**ST ALOYSIUS COLLEGE REDEVELOPMENT SSD 8669  
SUBMISSION BY THE OWNERS CORPORATION SP1036:  
48 UPPER PITT STREET KIRRIBILLI.**

*Photograph A – View from Unit 6, 2nd floor 48 Upper Pitt St.*

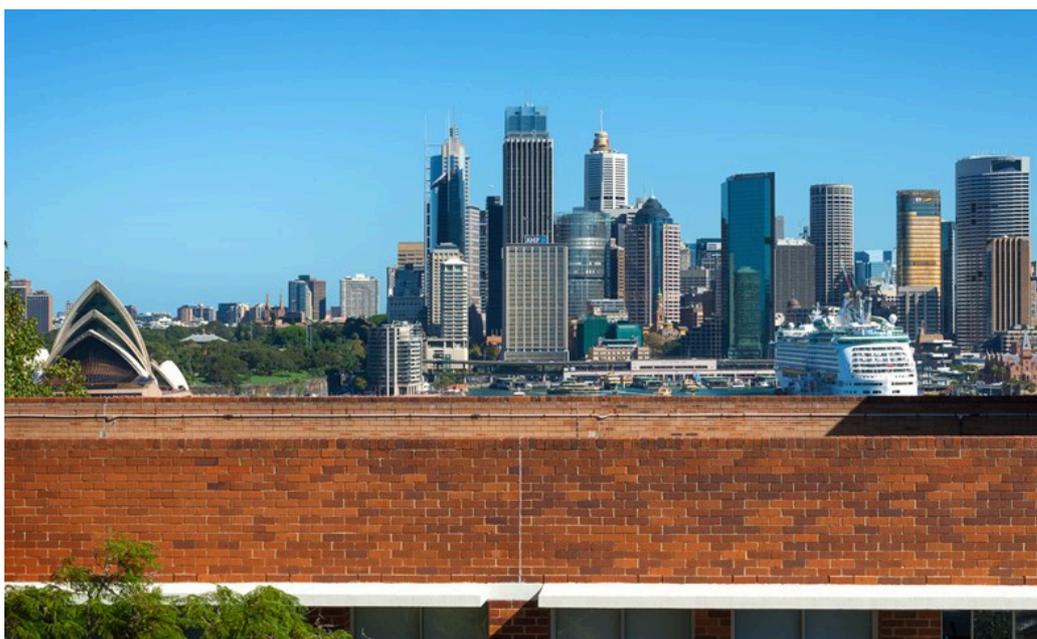
We note that the view impact assessment in the Development Application uses photographs taken from unit 27, which is on the 5th floor of 48 Upper Pitt St. The view impact from units on the 2nd and 3rd floor is more significant, particularly the impact of the proposed balustrade and screen to the south and east edges of the roof-top play area. Refer to photographs A and B.

The drawings of the new East Wing on Upper Pitt Street appear to show an increase in the parapet height from the existing RL43.21 to RL43.49, an increase of 0.28m. Similarly, the new façade element above the main entrance appears to be raised from existing RL46.29 to RL46.96 an increase of 0.67m. Both changes appear to be quite unnecessary and would have a severe impact on views from the 2nd floor units, as shown in photograph A.

Some of the parapet heights are not entirely clear, or may contain errors. For example Section 3 on sheet DAU301 shows parapet to the new East Wing as RL46.64 rather than the intended RL43.49 for that part of the section.

- Height frames to indicate position and height of the parapets, glass roof top canopy, new lift motor room and plant enclosures.
- Details of proposed glass balustrade and screen to the roof-top play areas. The screen, from 1200mm to 2400mm height above finished roof-top, should be clear frameless glass, without metal posts or support frames, to minimise view loss.

- Amended parapet heights to the new East Wing and the new main entrance façade element, to keep them at or below the existing heights in the same locations.
- Amended consultation strategy during construction, to include regular coordination between the college, its builder / project manager and a representative of the Strata Committee.
- No sound amplification shall be used on the roof top play areas.
- Hours of use for the roof-top play areas be restricted to normal school hours.
- That out-of-hours use of the roof-top be restricted to New Years Eve, from 5pm on 31st December to 1:30am on 1st January, and Australia Day, 26th January, between 9am and 9pm.
- That roof-top shade structures and mature planting be kept below the view lines from the sitting positions in all 3rd floor units at 48 Upper Pitt St.
